City of Madison

Conditional Use Alteration

Project Name
Washington Plaza

LETTER OF INTENT
March 23, 2016

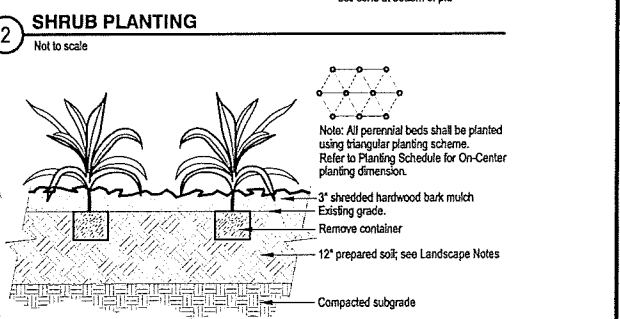
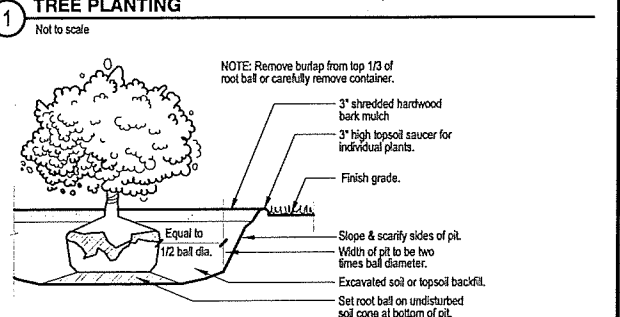
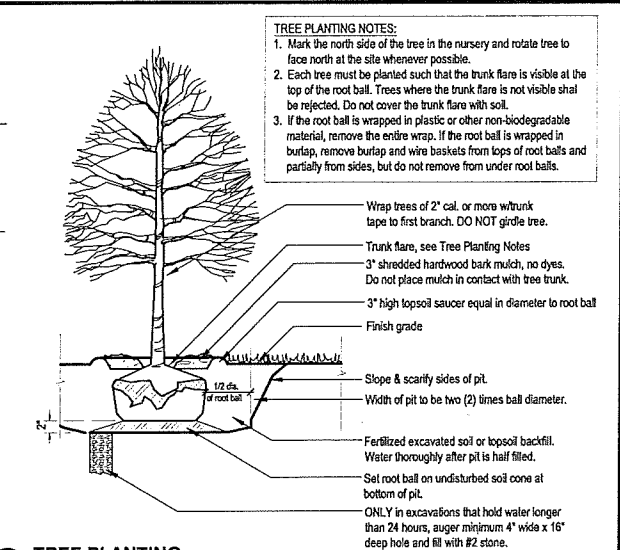
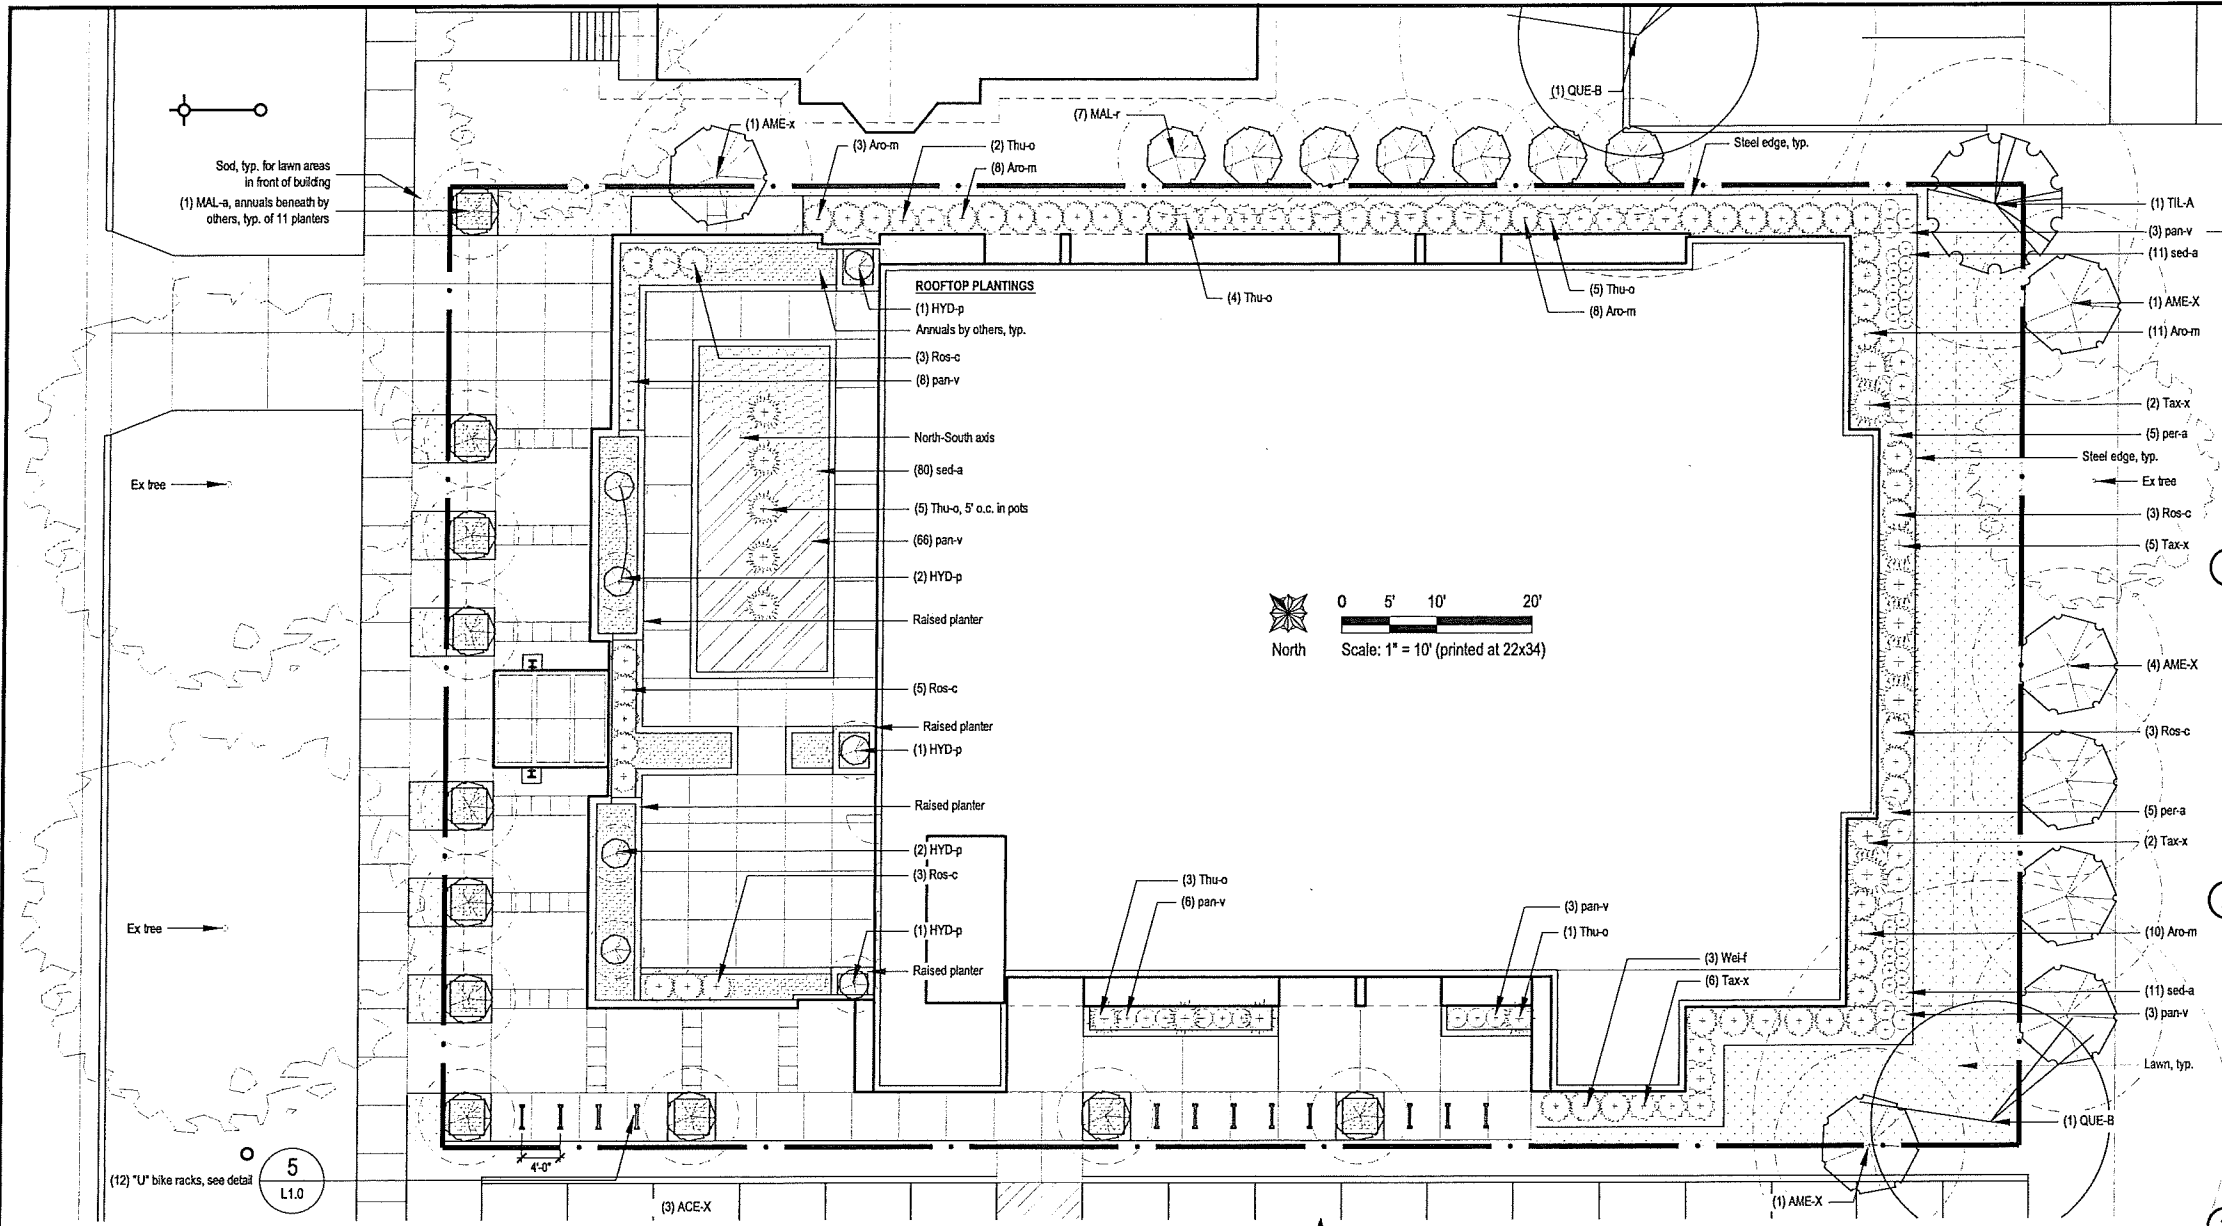
At UDC June 1, 2016, we were asked to provide more details regarding fencing changes. With this submission we have: Added detailed fence section and elevation with dimensions and notes.

Wood fence reduced to 4' height and stained dark bronze.

Add metal mesh module to the top of the wood fence matching the existing deck detail also in dark bronze.

Added sheet with colored photos showing the existing fence, rail and deck.

PROJECT
Washington Plaza
425 W. Washington Avenue
Madison, Wisconsin 53703
DRAWING
Site Plan Changes

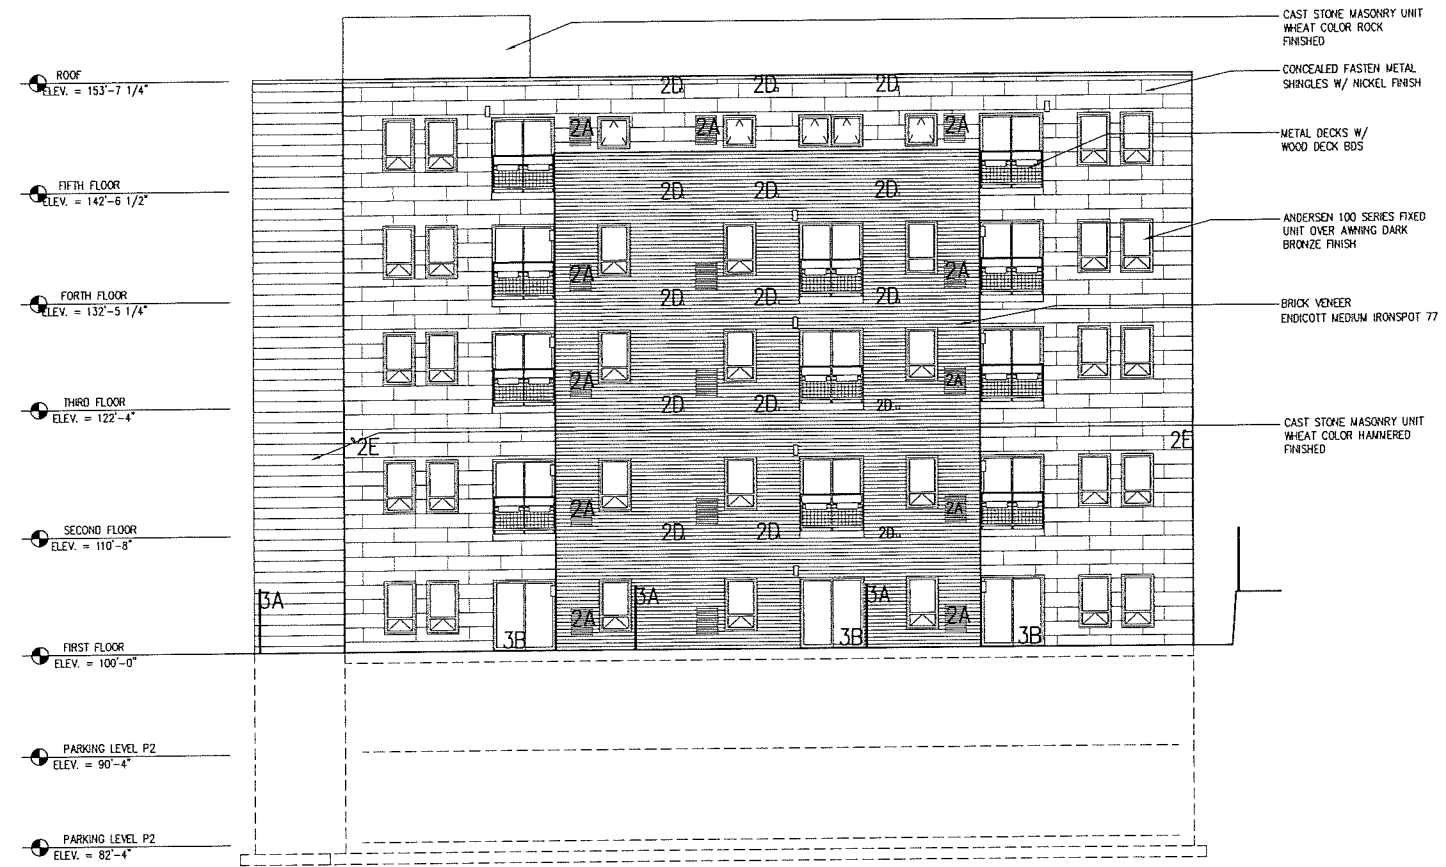
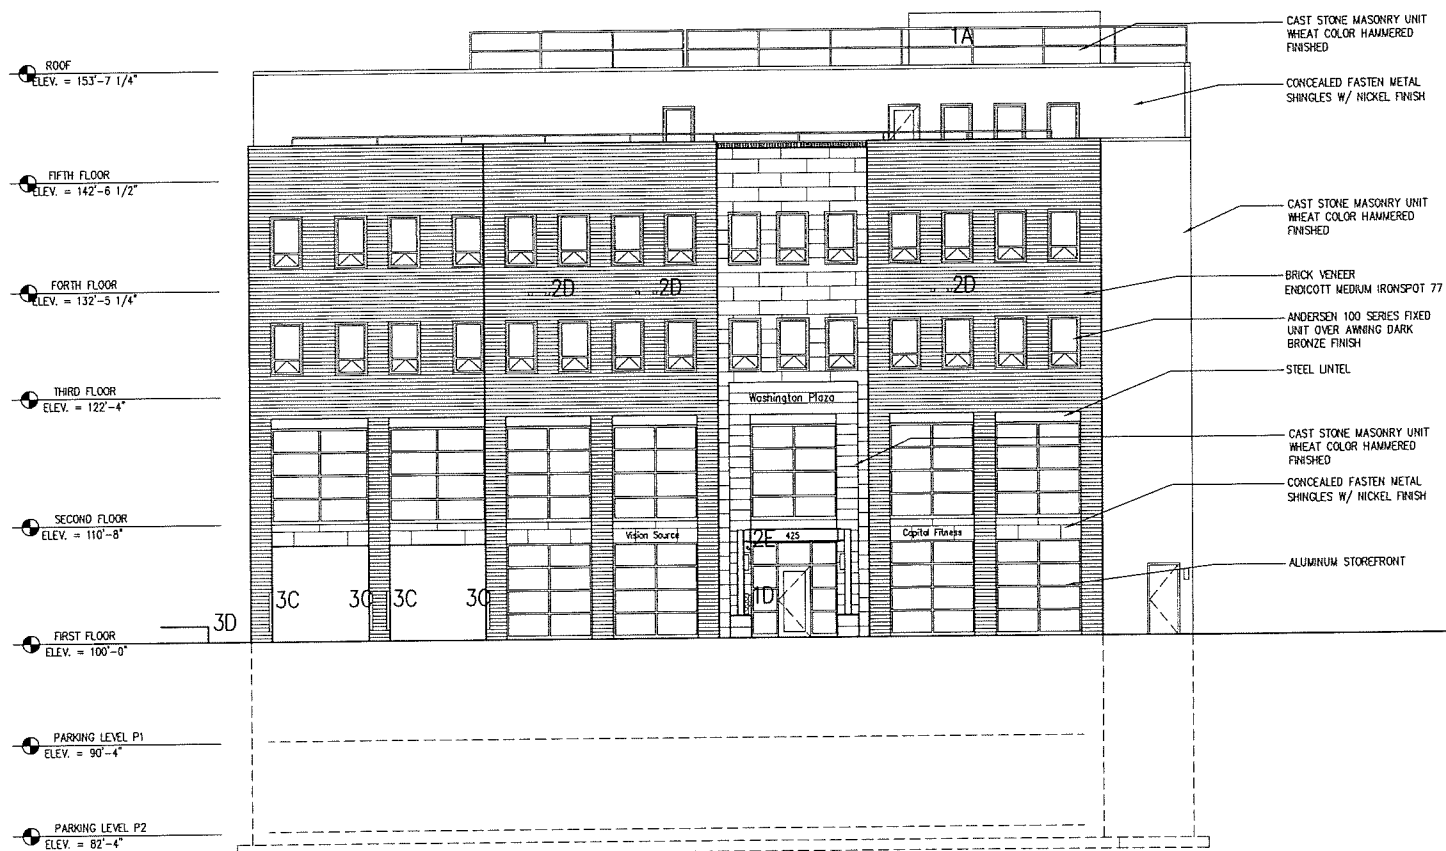
- 1A Railing installed according to Fire Department direction.
- 1B Additional equipment for back-up generator required by code.
- 1C Building code limitation on openings allowed per floor.
- 1D Fire Department required hose connection.

- ~~2A* Apartment HVAC vents did not fit in allowed width and had to be relocated.~~ **
- 2B Additional HVAC was required for commercial space.
- 2C Intake and exhaust required for design.
- 2D Dryer vents located where structure allowed access.
- 2E Security cameras.
- 2F MG&E required location for transformer replaced one planter.

- 3A 6 foot wood fence for ground floor apartments to screen lights from adjacent parking lots and provide security due to lower elevation.
- 3B Remove ground cover plantings and replace with pavers for tenant use of apartments on ground floor.
- 3C Add metal angles to protect masonry at garage entrance in place of raised curb.
- 3D Replace and add masonry retaining wall to improve site drainage.

2 ROOF TERRACE RAIL DETAIL - BUILT
 A3.6 SCALE: 1 1/2" = 1'-0"

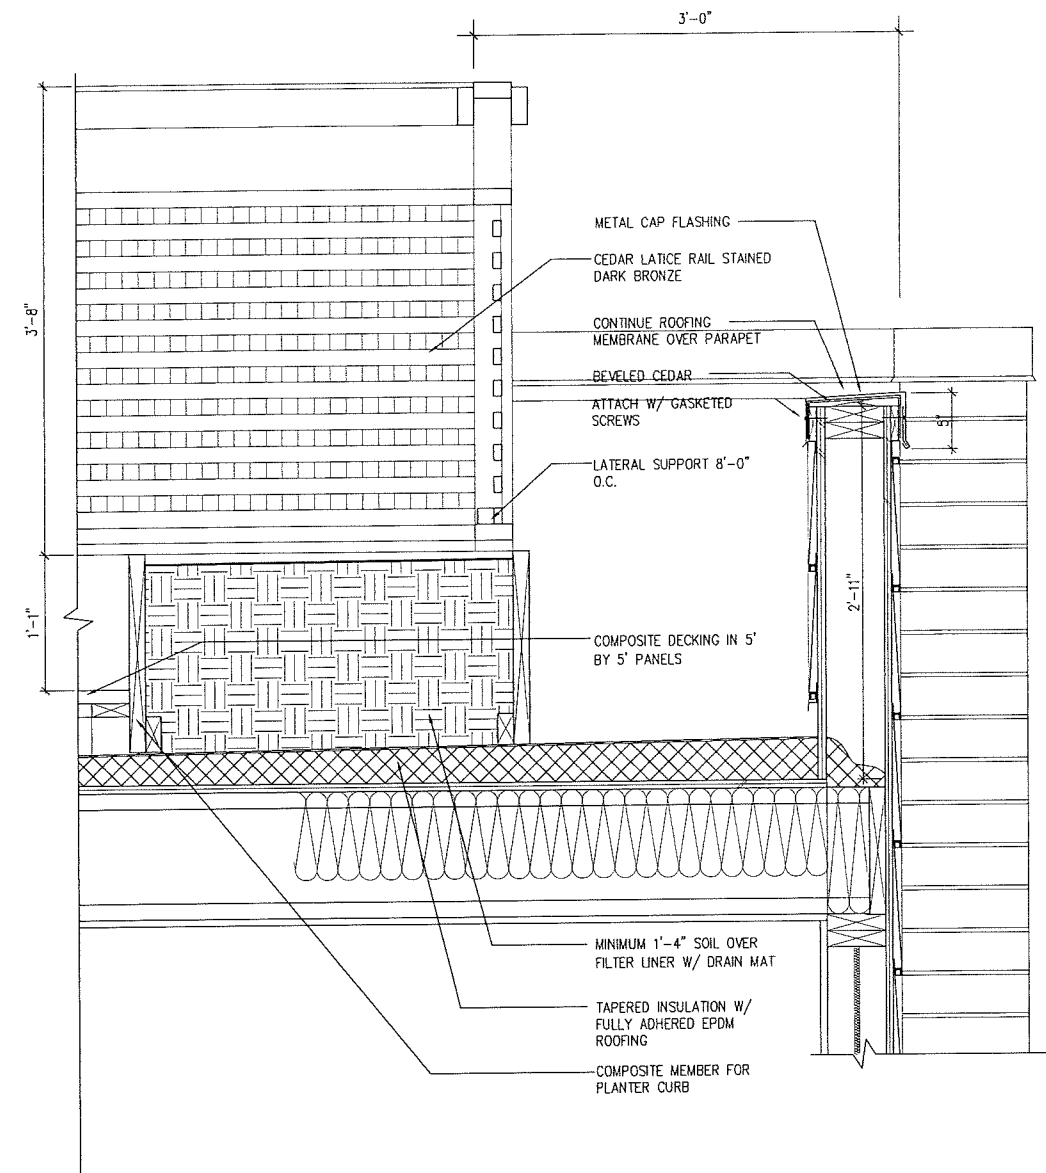
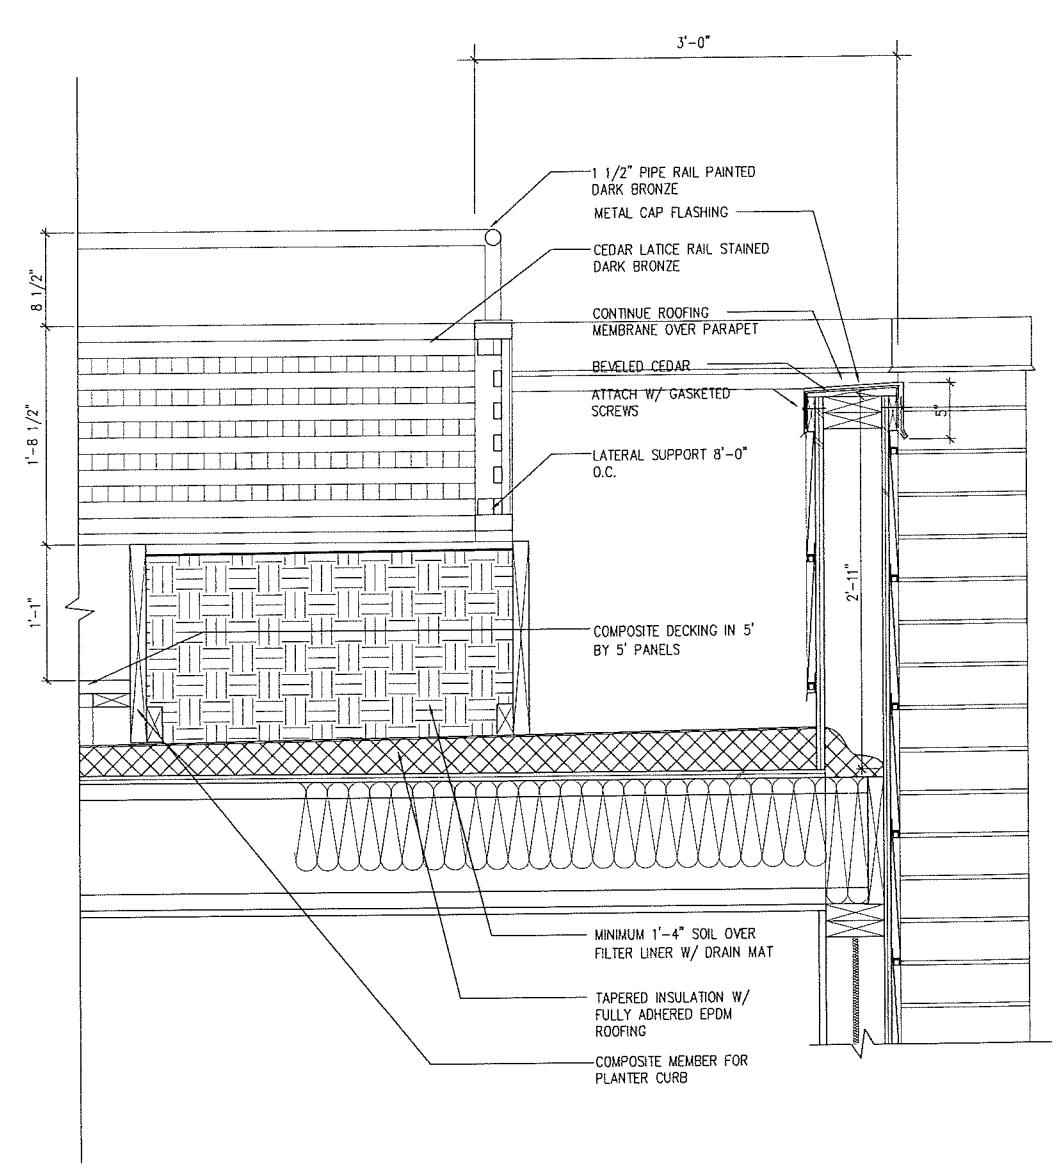
This is in response to the city staff requesting as built showing all components for the Washington Plaza project. As a result, we were asked to submit 4 items to be reviewed by UDC. First was a wooden trellis on the rooftop terrace. This will be removed instead. Second was the railing for the rooftop terrace as it was built higher than approved and in different material. It has been redesigned to be lowered to the original height with the top rail in metal and finish to match the approved design. Third was the modification of the landscape plan to replace concrete sidewalk and planting area with brick pavers for individual tenant patio areas. We verified that we did not exceed the 90% area covered. Fourth is the addition of privacy fencing not on the original submission. This has been redesigned to match architecture.
